E5071B-06E

S E R V I C E N O T E

E5071B ENA Series Network Analyzer, 300 kHz to 8.5 GHz

Change the RF signal path configuration and update firmware to 5.02 or later to improve the input damage level tolerance

**Figure 1 Front View (Semi-rigid Cables Opt. 213 before modification)**

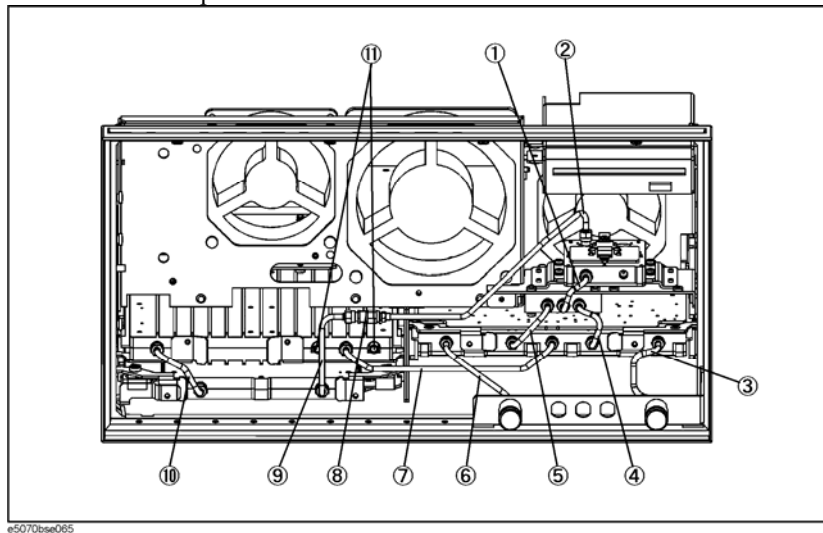
1. Remove outer cover. *1
2. Remove front panel. *1
3. Remove A28 Floppy Disk Drive (FDD) unit. *1
4. Remove semi-rigid cables in figure 1 No. 1 (E5070-61685) and No. 2 (E5070-61672)
5. Remove defective A4 Power amp module *1

Figure 2 Make A7 attenuator assembly (for option 213)

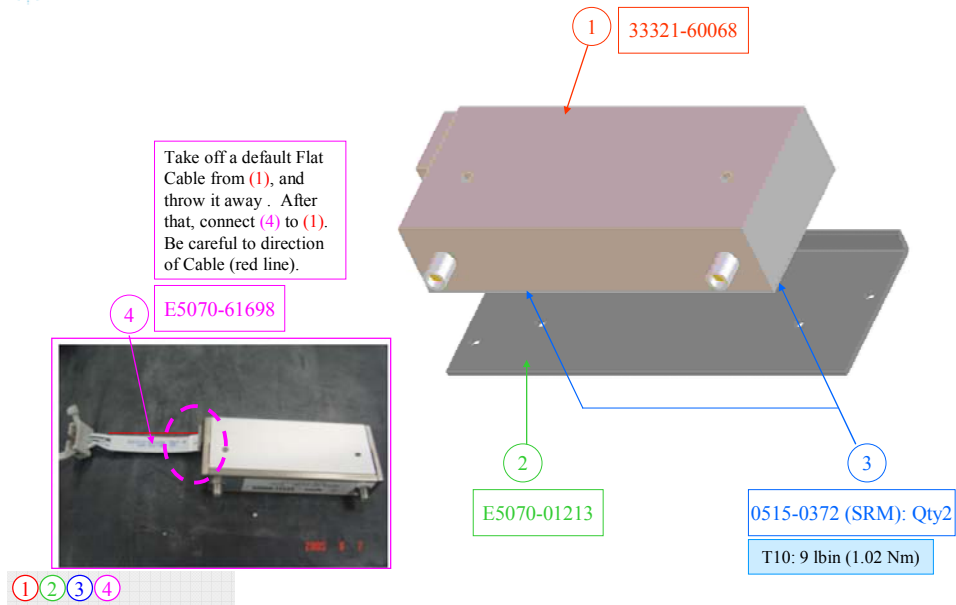
- Make A7 step attenuator assembly by 33321-60068 (1ea), E5070-61698 (1ea), E5070-01213 (1ea), 0515-0372 (2ea) and E5070-61617 (1ea). E5070-61698 is the cable between 33321-60068 and E5070-61617.

Figure 3 Install A7 attenuator assembly (for option 213)

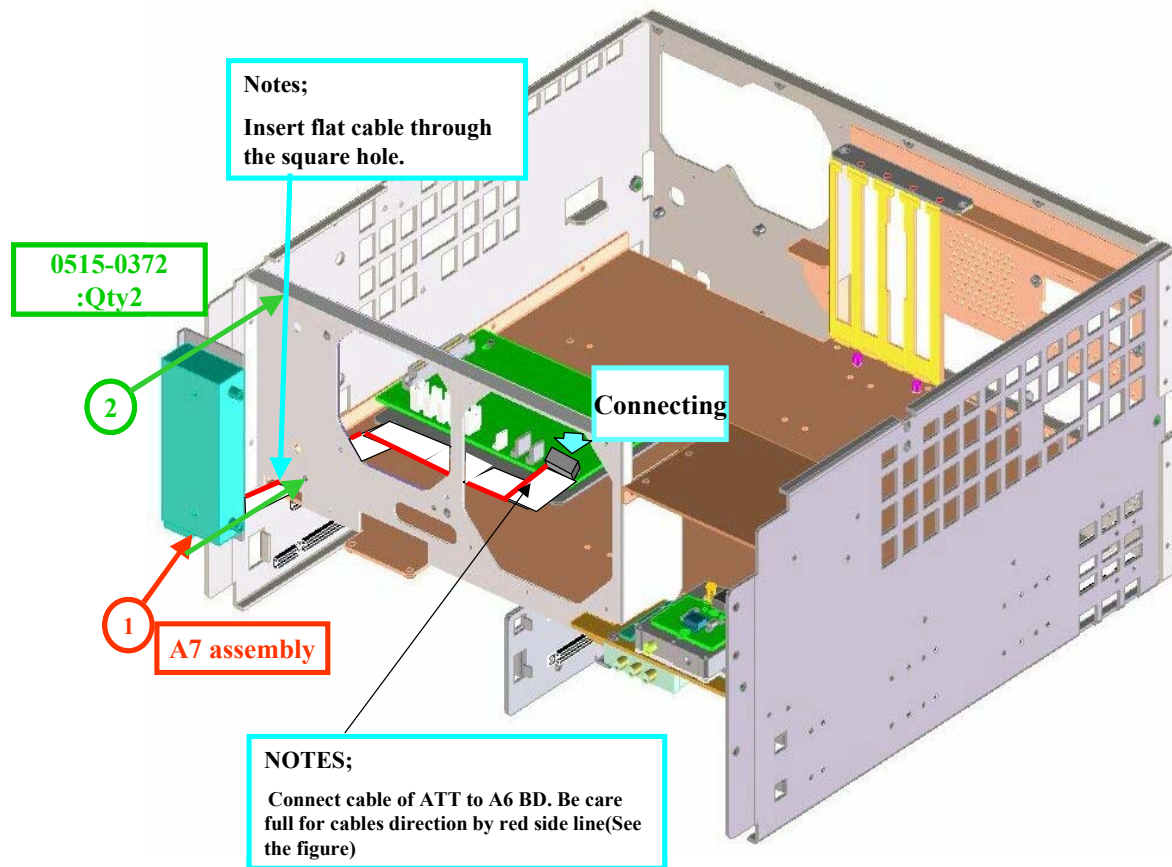
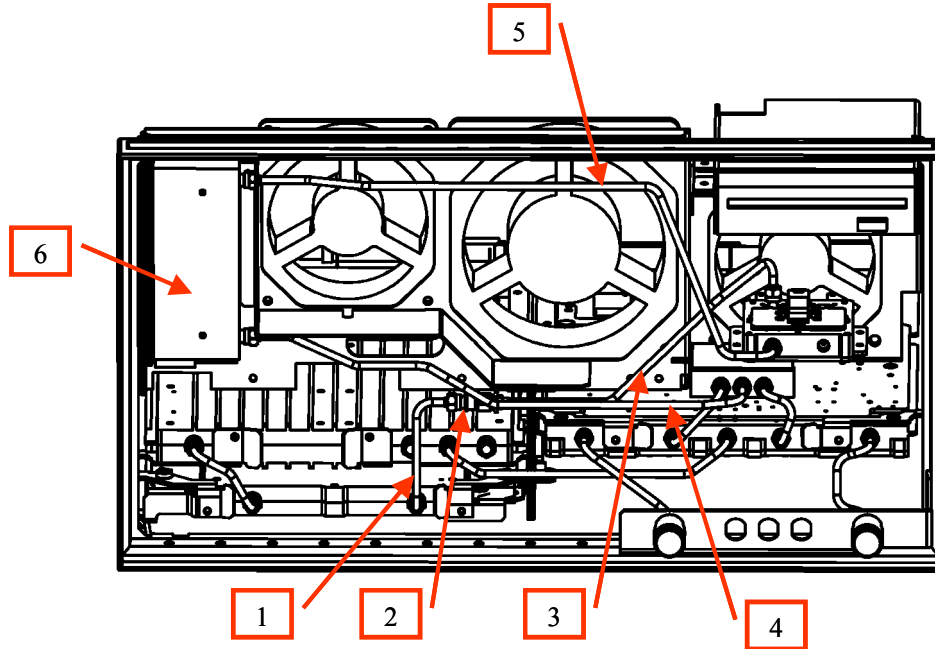
- Install A7 assembly with 0515-0372 2 ea. Be careful to flat cable direction and its connectivity.

8. Install new A4 power amp module to an original place.
9. Connect uW attenuator 0955-0208 (No 2 in Figure4) and A4 with E5070-61672 semi-rigid cable (No 3 in Figure 4)
10. Connect A4 and A7 ATT with E5070-61633 semi-rigid cable (No 5 in Figure 4)
11. Connect A7 ATT and A8 with E5070-61634 semi-rigid cable (No 4 in Figure 4)

Figure 5 Front View (Miscellaneous Parts)

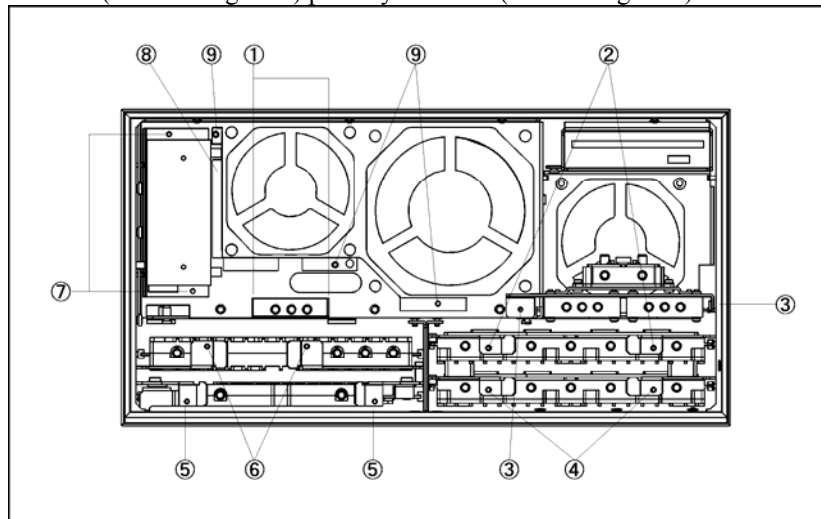
1. Remove outer cover. *1
 2. Remove front panel. *1
 3. Remove A28 Floppy Disk Drive (FDD) unit. *1
 4. Remove E5070-01222 (No. 8 in Figure 5) plate by 3 screws (No.9 in Figure 5)
- *1: Refer to E5070B/E5071B Service manual chapter 6 for details

Figure 6 Front View (Semirigid Cables Opt. 214 before modification)

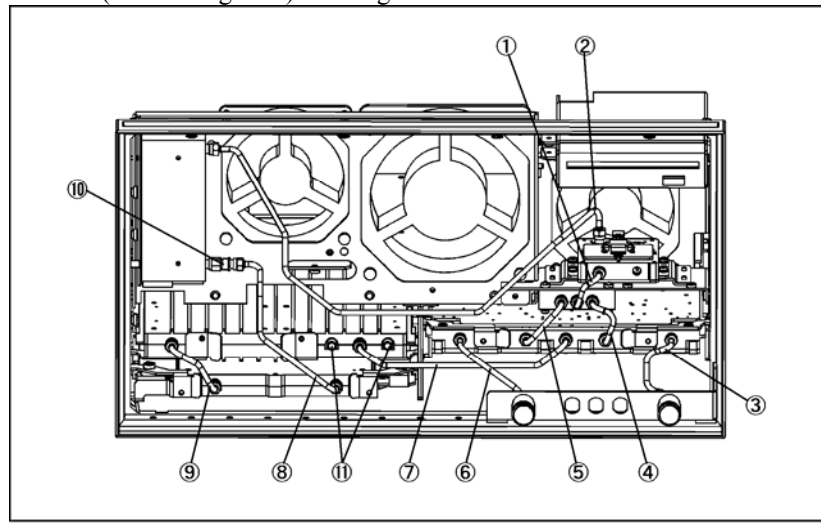
5. Remove E5070-61673 (No. 8 in Figure 6) semi-rigid cable from A3 and 0955-0208 (No 10 in Figure 6) attenuator
6. Remove 0955-0208 (No 10 in Figure 6) attenuator from A7 ATT module
7. Remove E5070-61674 (No 2 in Figure 6) semi-rigid cable from ATT and A4 amp
8. Remove E5070-61685 (No 1 in Figure 6) semi-rigid cable from A4 and A8 switch.

Figure 7 Front View (Semi-rigid Cables Opt. 313 before modification)

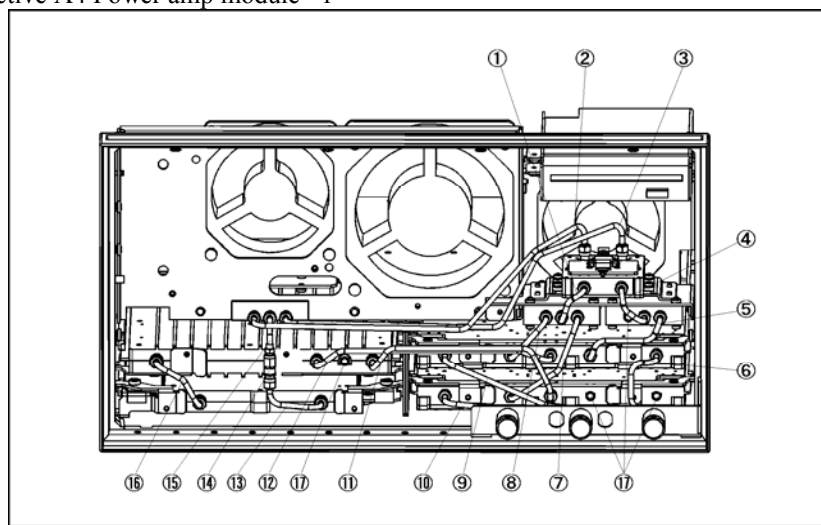
1. Remove outer cover. *1
2. Remove front panel. *1
3. Remove A28 Floppy Disk Drive (FDD) unit. *1
4. Remove E5070-01222 (No. 8 in Figure 5) plate by 3 screws (No.9 in Figure 5)
5. Remove E5070-61685 (No 1 and No 4 in Figure 7) semi-rigid cables from A4 and A8 (receiver side)
6. Remove E5070-61677 (No 2 in Figure 7) and E5070-61678 (No 3 in Figure 7) semi-rigid cables from A4 and A8 (source side)
7. Remove defective A4 Power amp module *1

Figure 8 Make A7 attenuator assembly (for option 313, 314, 413, 414)

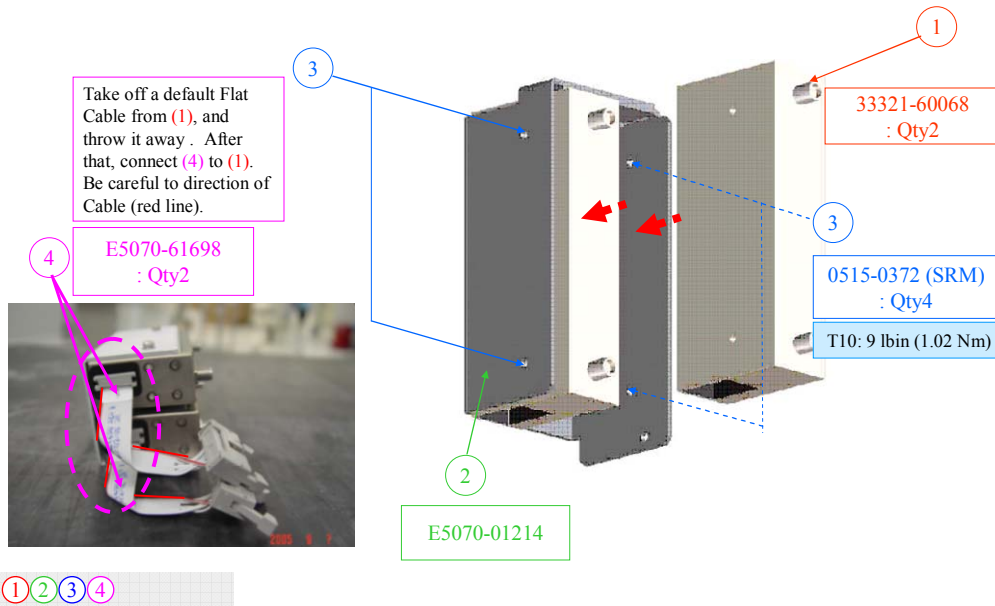
- Make A7 step attenuator assembly by 33321-60068 (2ea), E5070-61698 (2ea), E5070-01214 (1ea), 0515-0372 (4ea) and E5070-61618 (1ea). 2ea of E5070-61698 is the cable between 33321-60068 and E5070-61618.

Figure 9 Install A7 attenuator assembly (for option 313, 314, 413, 414)

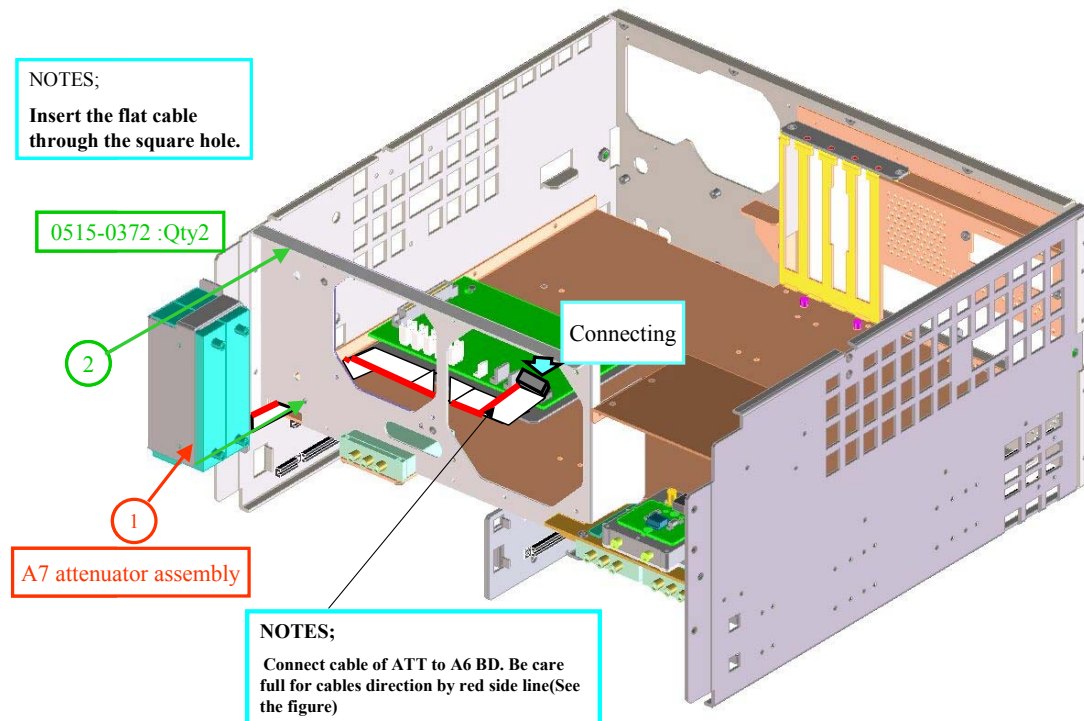
- Install A7 assembly with 0515-0372 2 ea. Be careful to the flat cable's direction and connection.

Figure 10 Front View (Semirigid Cables Opt. 313, 314 after modification)

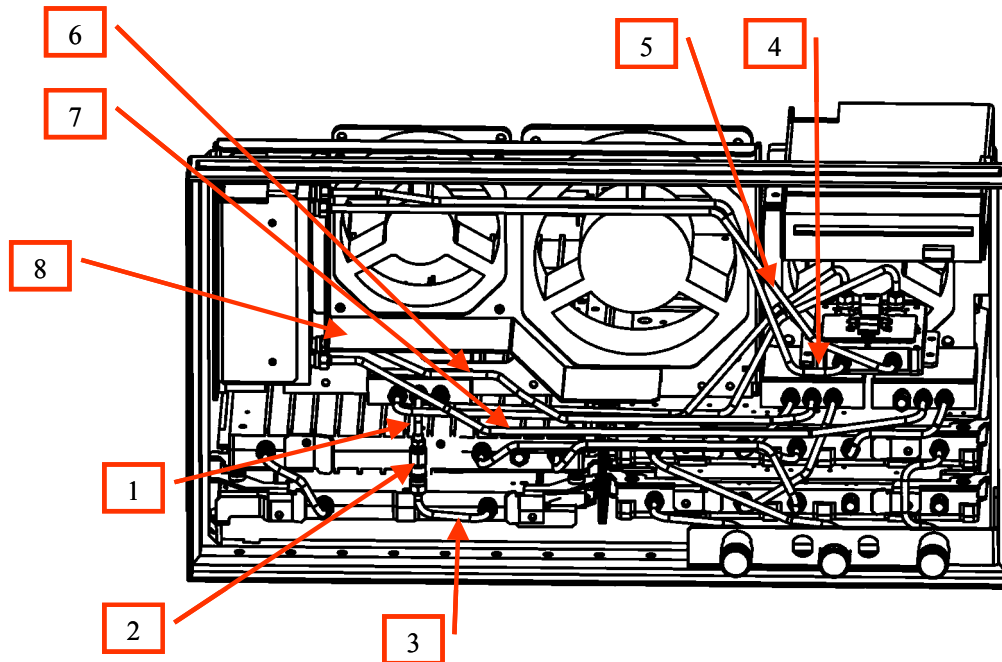
10. Install new A4 power amp module to an original place.
11. Connect A8 (source side) and A4 with E5070-61677 and E5070-61678 that is removed in step 6.
12. Connect A4 and A7 ATT with E5070-61633 (No 4 in Figure10) semi-rigid cable
13. Connect A4 and A7 ATT with E5070-61635 (No 5 in Figure 10) semi-rigid cable
14. Connect ATT and A8 with E5070-61634 (No 6 in Figure 10) semi-rigid cable
15. Connect ATT and A8 with E5070-61636 (No 7 in Figure 10) semi-rigid cable

16. Screw E5070-01223 plate (No 8 in figure 10) instead of E5070-01222
17. To avoid the friction between new semi-rigid cables and front panel's cable clamp, remove two 1400-0611, cable clamp, from original place, then stick two new 1400-0611, cable clamp, as shown in Figure 11 lower. Then change a bending position of LCD flat cable (white one) according to Figure 11 upper.

Figure 11 New cable clamp position and cable bending reference

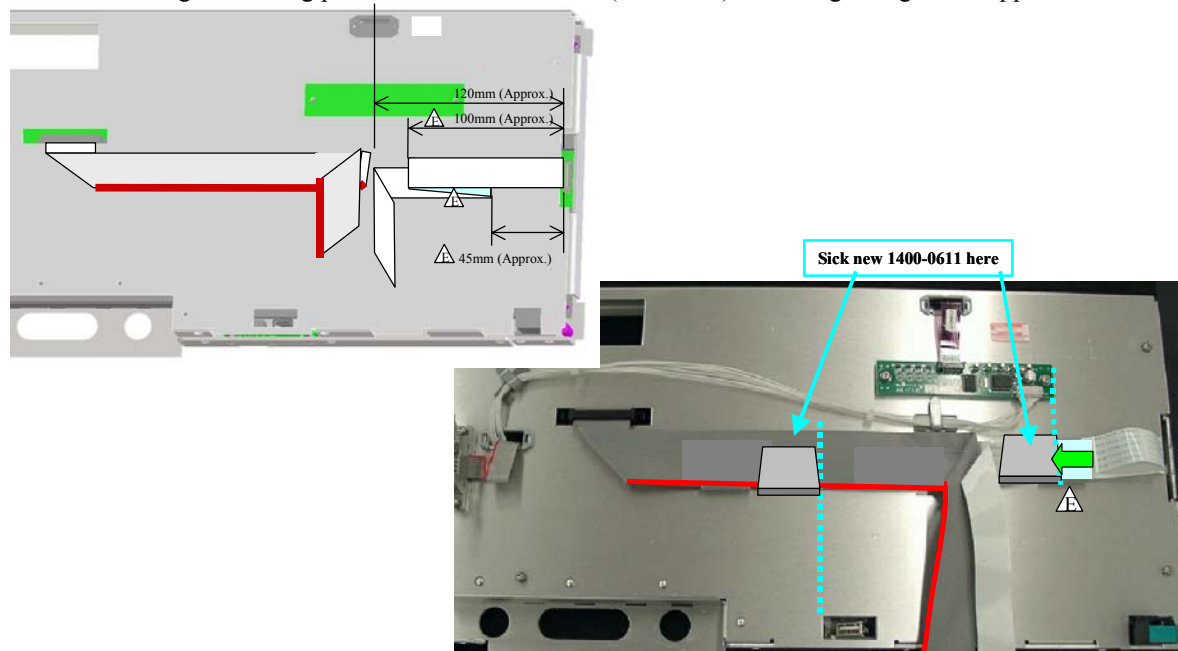
22. Screw E5070-01223 plate (No 8 in figure 10) instead of E5070-01222
23. To avoid the friction between new semi-rigid cables and front panel's cable clamp, remove two 1400-0611, cable clamp, from original place, then stick two new 1400-0611, cable clamp, as shown in Figure 11 lower. Then change a bending position of LCD flat cable (white one) according to Figure 11 upper

Figure 12 Front View (Semirigid Cables Opt. 314 before modification)

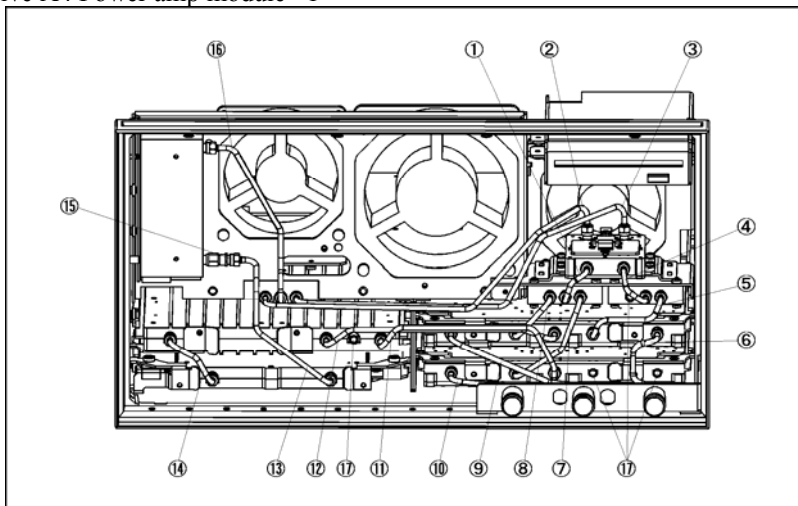
1. Remove outer cover. *1
2. Remove front panel. *1
3. Remove A28 Floppy Disk Drive (FDD) unit. *1
4. Remove E5070-01222 (No. 8 in Figure 5) plate by 3 screws (No.9 in Figure 5)
5. Remove E5070-61685 (No 1 and No 4 in Figure 12) semi-rigid cables from A4 and A8 (receiver side)
6. Remove E5070-61677 (No 2 in Figure 12) and E5070-61678 (No 3 in Figure 12) from A4 and A8 (source side)
7. Remove E5070-61673 (No 13 in Figure 12) semi-rigid cable from A3 and 0955-0301 (No 15 in Figure 12).
8. Remove 0955-0301 (No 15 in Figure 12) uW attenuator from A7 ATT
9. Remove E5070-61656 (No 16 in Figure 12) semi-rigid cable from A7 and A8
10. Remove defective A4 Power amp module *1

Figure 13 Front View (Semirigid Cables Opt. 413 before modification)

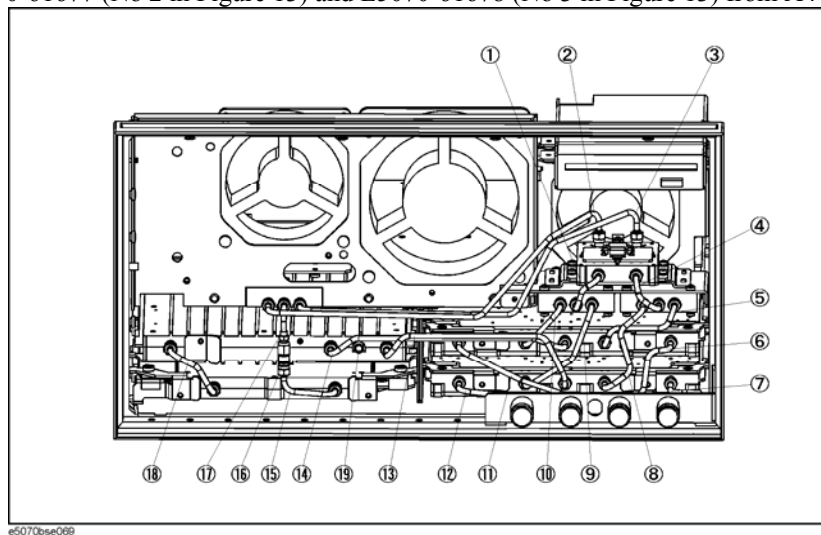
1. Remove outer cover. *1
2. Remove front panel. *1
3. Remove A28 Floppy Disk Drive (FDD) unit. *1
4. Remove E5070-01222 (No. 8 in Figure 5) plate by 3 screws (No.9 in Figure 5)
5. Remove E5070-61685 (No 1 and No 4 in Figure 13) semi-rigid cables from A4 and A8 (receiver side)
6. Remove E5070-61677 (No 2 in Figure 13) and E5070-61678 (No 3 in Figure 13) from A4 and A8 (source side)

Figure 14 Front View (Semirigid Cables Opt. 413, 414 after modification)

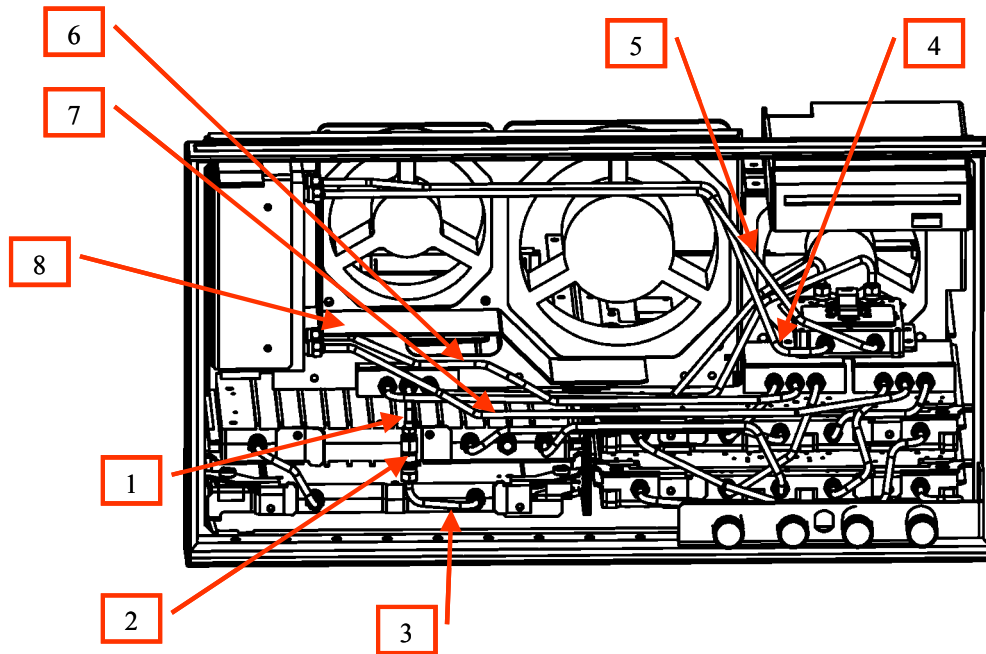
8. Make A7 step attenuator assembly by 33321-60068 (2ea), E5070-61698 (2ea), E5070-01214 (1ea), 0515-0372 (4ea), and E5070-61618 (1ea). Refer to Figure 8 for the detail.
9. Install A7 assembly with 0515-0372 2 ea. Be careful to the flat cable's direction and connection. Refer to Figure 9 for the detail.
10. Install new A4 power amp module to an original place
11. Connect A8 (source side) and A4 with E5070-61677 and E5070-61678 that are removed in step 6
12. Connect A4 and A7 ATT with E5070-61633 (No 4 in Figure14) semi-rigid cable
13. Connect A4 and A7 ATT with E5070-61635 (No 5 in Figure 14) semi-rigid cable
14. Connect ATT and A8 with E5070-61634 (No 6 in Figure 14) semi-rigid cable
15. Connect ATT and A8 with E5070-61636 (No 7 in Figure 14) semi-rigid cable
16. Screw E5070-01223 plate (No 8 in figure 14) instead of E5070-01222

Figure 15 Front View (Semirigid Cables Opt. 414 before modification)

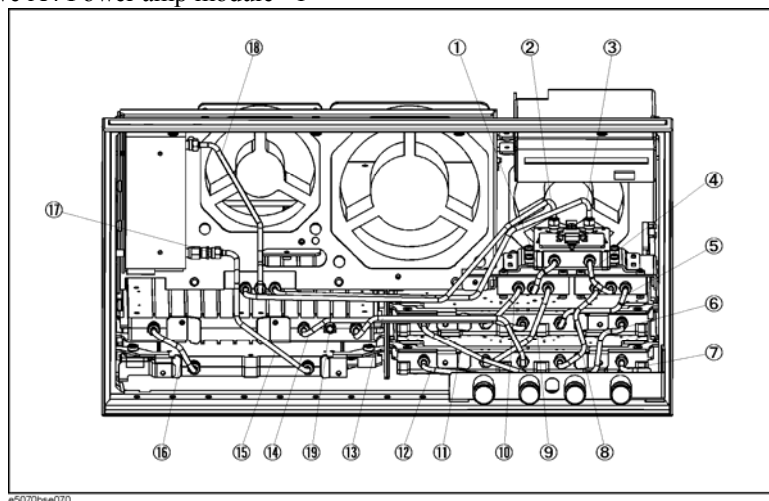
1. Remove outer cover. *1
2. Remove front panel. *1
3. Remove floppy disk drive unit. *1
4. Remove E5070-01222 (No. 8 in Figure 5) plate by 3 screws (No.9 in Figure 5)
5. Remove E5070-61685 (No 1 and No 4 in Figure 15) semi-rigid cables from A4 and A8
6. Remove E5070-61677 (No 2 in Figure 15) and E5070-61678 (No 3 in Figure 15) from A4 and A8 (source side)
7. Remove E5070-61673 (No 15 in Figure 15) semi-rigid cable from A3 and 0955-0301 (No 17 in Figure 15).
8. Remove 0955-0301 (No 17 in Figure 15) uW attenuator from A7 ATT
9. Remove E5070-61656 (No 18 in Figure 15) semi-rigid cable from A7 and A8
10. Remove defective A4 Power amp module *1
